Charlotte Department of Transportation

Memorandum

Subject: Rezoning Petition 15-053: Approximately 0.0466 acres located on the southwest corner at the intersection of Montford Drive and Park Road.

Figure 1

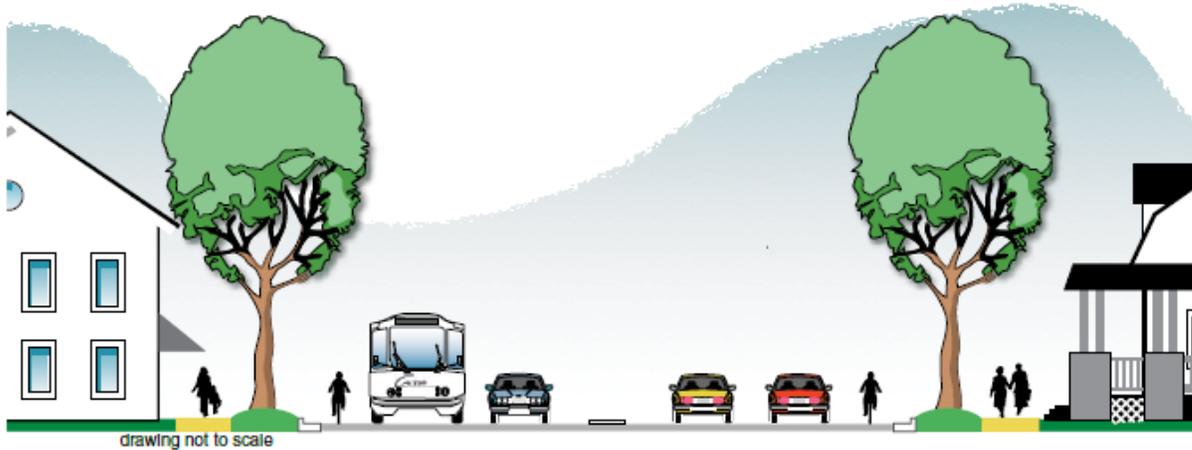
1. See Figure 1 for the future typical section for the site's Park Road frontage per the Park Woodlawn Area Plan (section A3):

The application of this typical section would result in two 11'-wide travel lanes measured from the edge of the existing median island, a 5'-wide bike lane, 2.5' curb and gutter, an 8'-wide planting strip, and an 8'-wide sidewalk. Thus, the future back of curb location would be 29.5', measured from the western edge of the existing median island. The petitioner needs to update the plans to reflect the appropriate future curb and sidewalk locations based on the aforementioned dimensions. Building setbacks are to be measured from this future back of curb location.

Figure 2

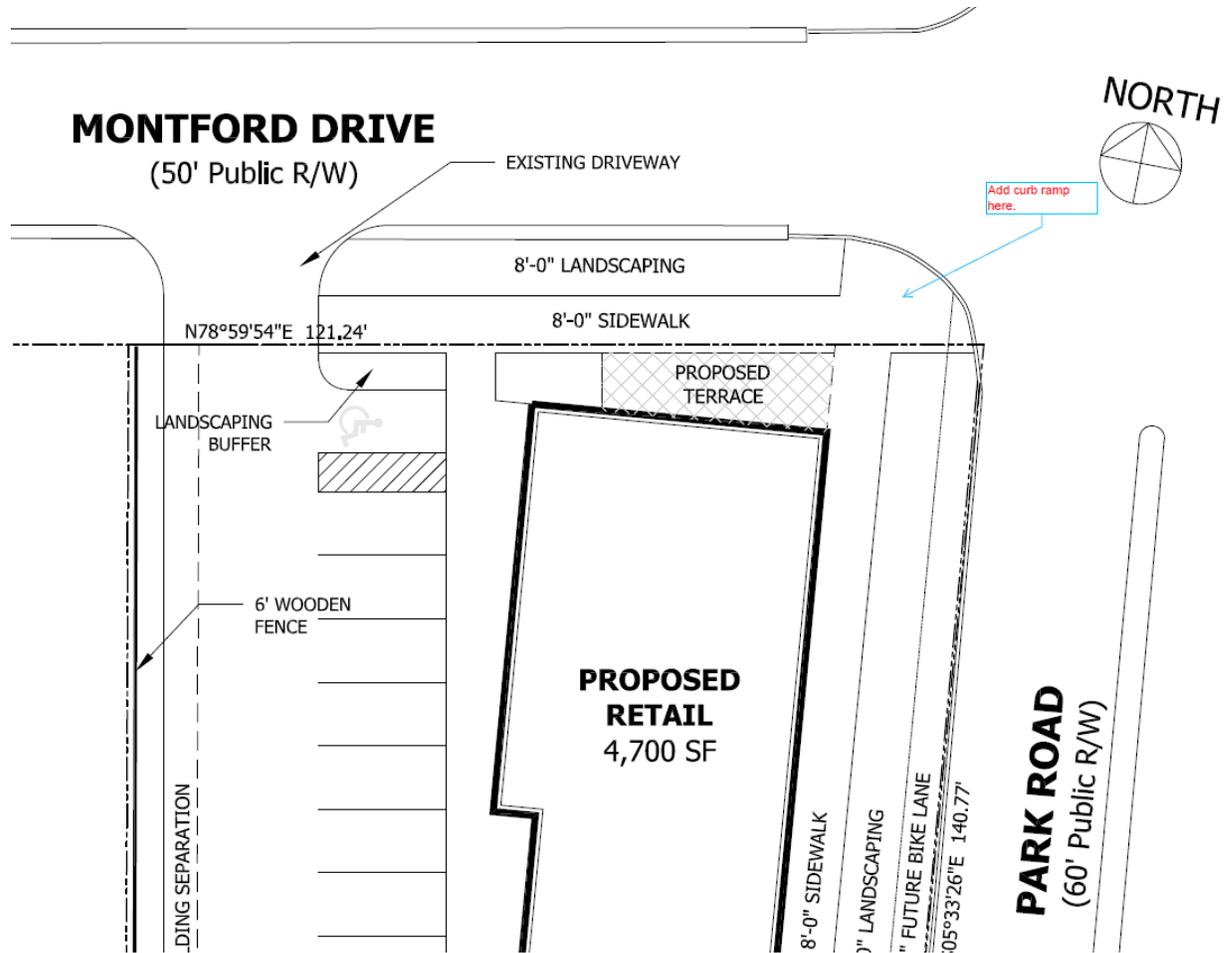
1. CDOT requests that the petitioner revise the plan to reflect a proposed curb ramp on the site's northeastern corner at the intersection of Park Road and Montford Drive. See Figure 2 below.
